Richmond Knobhill Community

Redevelopment Proposal

Viscount Bennett Redevelopment Report

Consolidate 5 Design options into 1

Proposed Land Use-consolidation

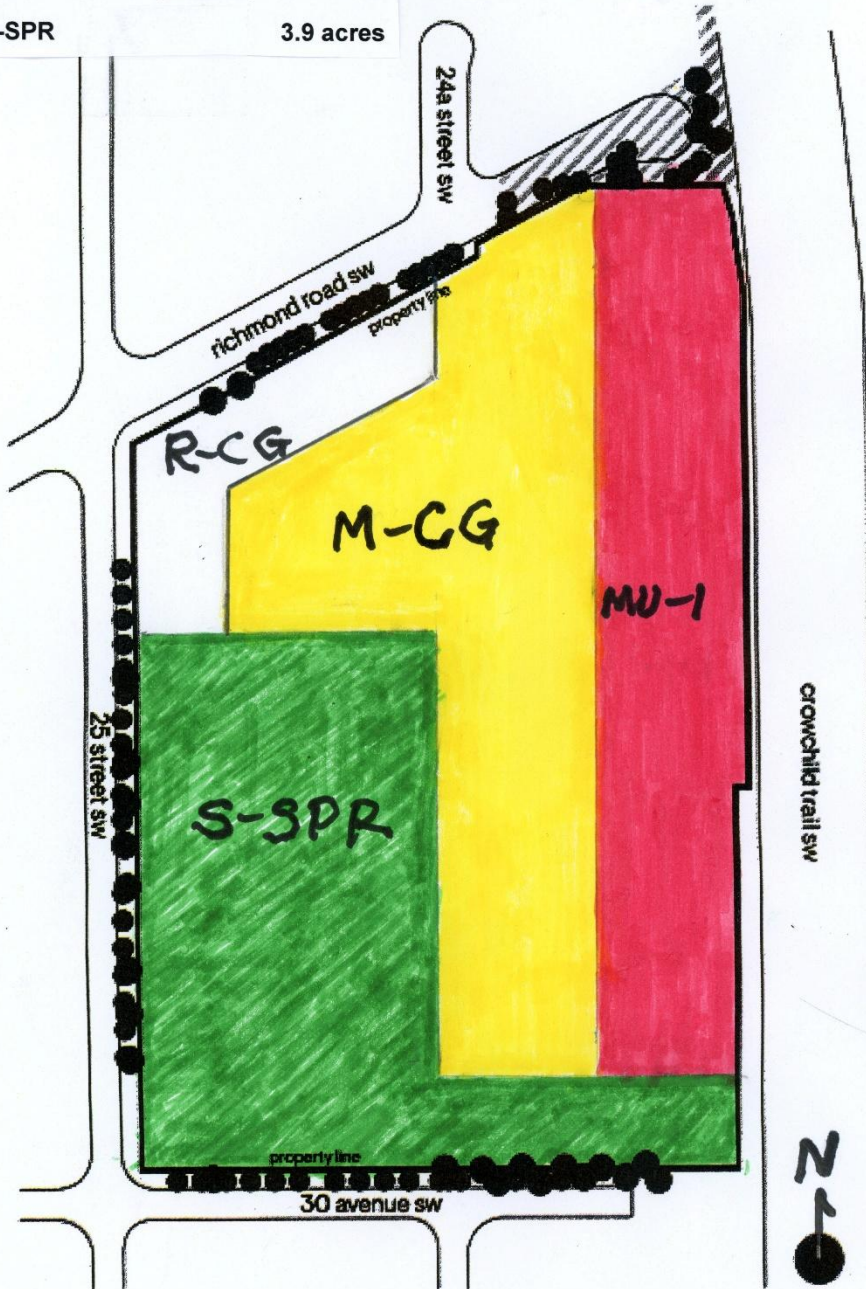
R-CG - up to 3 stories	.8 acres
M-CG - up to 3 stories	3.9 acres
MU-1 - up to 4 (f2.5h16)	2.9 acres
S-SPR	3.9 acres

Total Units - 460

UPA - 40
